APPARATUS AFFECTED: 35A-X3 Tape Teletypewriter Base

REASON: To add a fuse and mounting hardware.

Appendix 1, Section 574-204-400 Issue 1
Teletypewriter Change Notice
TCN 999 Issue 1
February, 1968

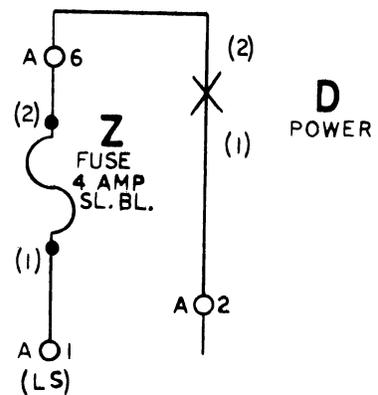
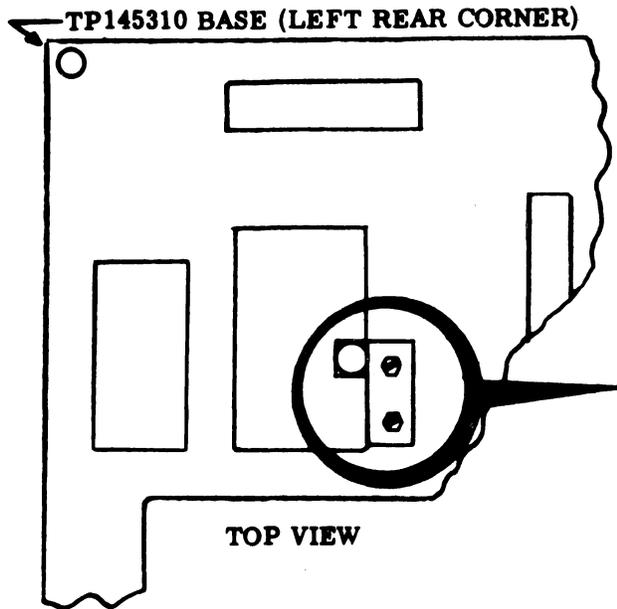
(1B) The wiring changes required to add a fuse to the power circuit are reflected in actual wiring diagram 5868WD, Issue 8 and schematic wiring diagrams 5869WD-B1, Issue 8, 5869WD-B2, Issue 9, 7792WD, Sheet 1, Issue 2 and 7792WD, Sheet 2, Issue 3. The schematic representation of the wiring changes is as follows:

Old-Style Wiring

New-Style Wiring

SUPPLEMENTAL INFORMATION: (1) When updating from the old-style to the new-style wiring the TP151819 strap on terminals 6 and 8 of the power input terminal block must be removed.

Attached Sheet 1

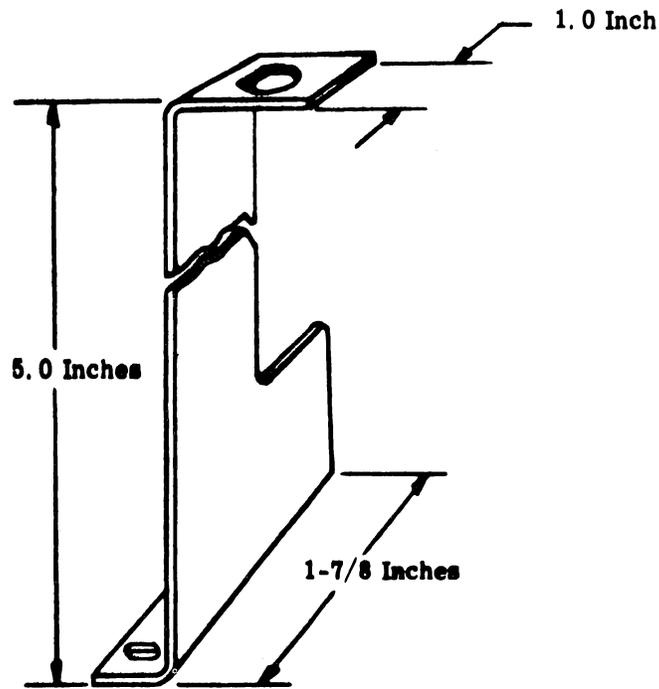
CHANGE: (1A) A TP328184 fuse bracket assembly is added to the 35A-X3 Tape Teletypewriter Base. The assembly consists of the following parts:

Refer to Attachment Sheet 1 for the mounting location of the fuse bracket assembly to the base.
